H. B. ROBINSON STEAM ELECTRIC PLANT, UNIT NO. 2

AMENDMENT TO FACILITY OPERATING LICENSE

Amendment No. 98
License No. DPR-23

SAFETY EVALUATION BY THE OFFICE OF NUCLEAR REACTOR REGULATION

CORE PROTECTION BOUNDARIES FOR 3-LOOP OPERATION
Figure 2.1-1

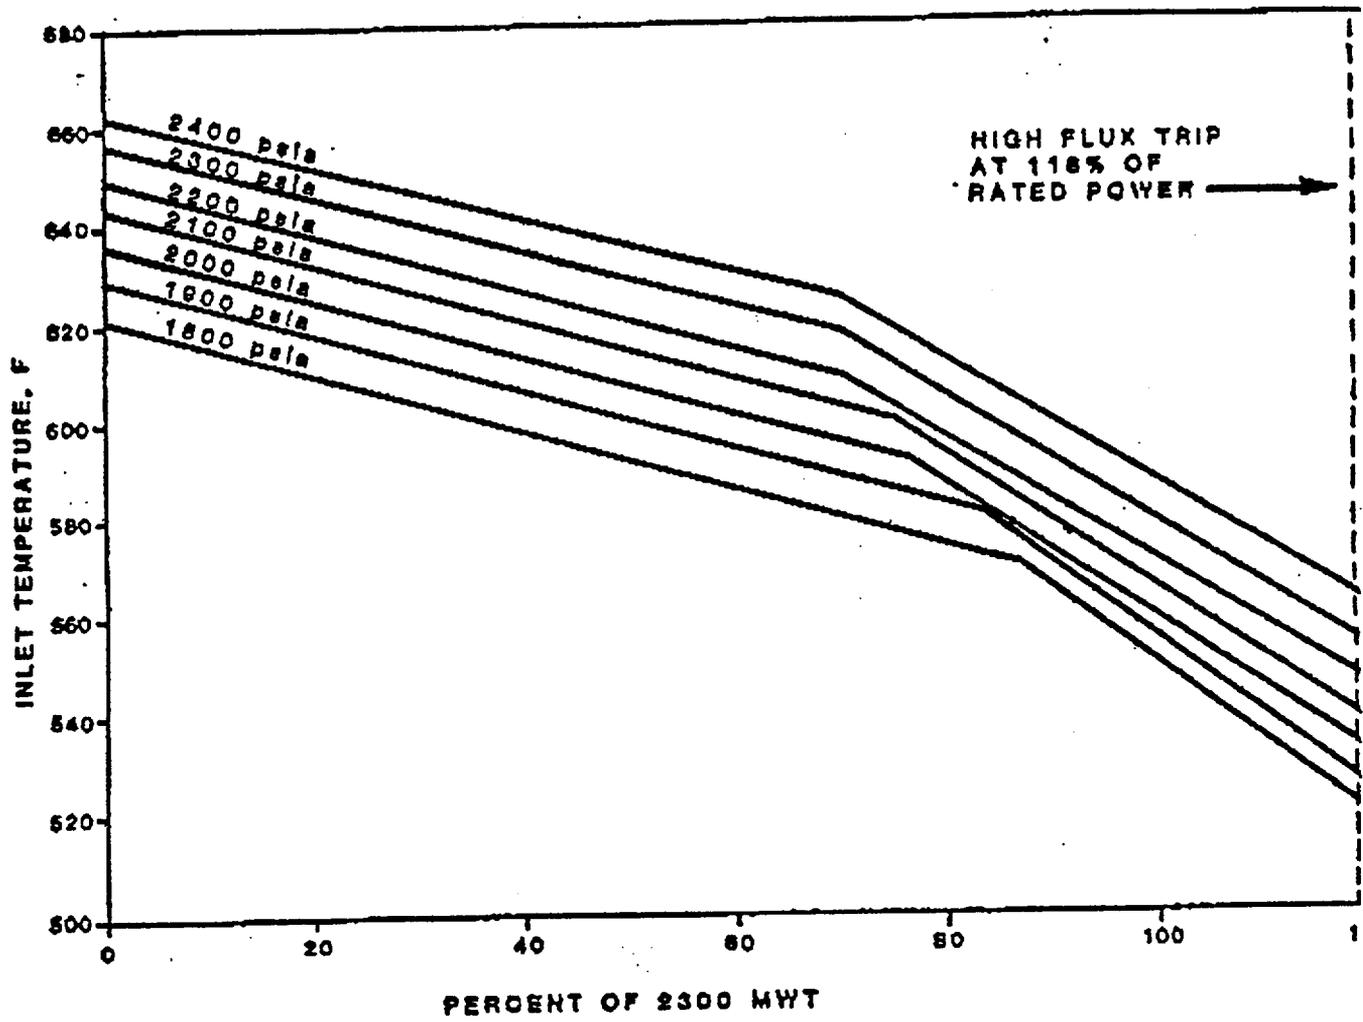
The amendment adds a minimum RCS flow to Section 2.1 Bases and Figure 2.1-1 of the Technical Specifications to assure that steady-state reactor coolant flow is maintained within the bounds of the cycle 10 safety analysis.

The safety limit curves given in Figure 2.1-1 are based on a minimum RCS flow of 97.3×10^6 lbm/hr. These curves would not be applicable in the case of a loss of flow transient. The evaluation of such an event would be based upon the analysis presented in Section 15.3 of the FSAR.

NOTE: BASED ON A MINIMUM RCS FLOW OF 97.3×10^6 lbm/hr

During the staff review of the H.B. Robinson-2 cycle-10 reload, the Carolina Power and Light Company (CP&L) committed to include in the Technical Specifications of the H. B. Robinson-2 plant a low reactor coolant loop flow trip setpoint which is not greater than 90 percent of the measured RCS flow less uncertainties (Ref. 1). The purpose of the commitment was to assure that the existing low flow trip setpoint bounded the design flow used in safety analyses, thus making it unnecessary to specify the design flow as a Technical Specification LCO. Shortly after the cycle-10 startup, a calorimetric flow determination was performed and the results were reported to the staff (Ref. 2). By letter dated August 28, 1985 (Ref. 3), CP&L requested a change in Technical Specification (TS) 2.1 to include specification of the minimum coolant flow assumed in the development of the core protection boundary operating limits in the basis of 2.1. By letter dated November 11, 1985, CP&L added the minimum flow to Figure 2.1-1 of the TS.

The H.B. Robinson-2 plant has an approved measured flow uncertainty of 1.8 percent (for the calorimetric method). Therefore, the minimum measured flow is 105.8×10^6 lbm/hr and the value which corresponds to 10 percent below that is 95.2×10^6 lbm/hr. The thermal design analysis flow is 97.30×10^6 lbm/hr and the minimum flow trip setpoint used in the analysis is 87.6×10^6 lbm/hr, i.e., 10 percent below the thermal design flow. The actual flow at trip is 95.2×10^6 lbm/hr.

The results of the flow measurements (Ref. 2) indicate that the low flow trip setpoint does not prevent operation with actual flow less than the design flow. The proposed Technical Specification change identifies the design flow assumed in the definition of Figure 2.1-1 operating boundaries and thus requires that the minimum flow of 97.3×10^6 lbm/hr be maintained by administrative controls.

We conclude that the proposed Technical Specification change provides appropriate assurance that steady-state reactor coolant flow is maintained within the bounds of the safety analyses and is, therefore, acceptable.
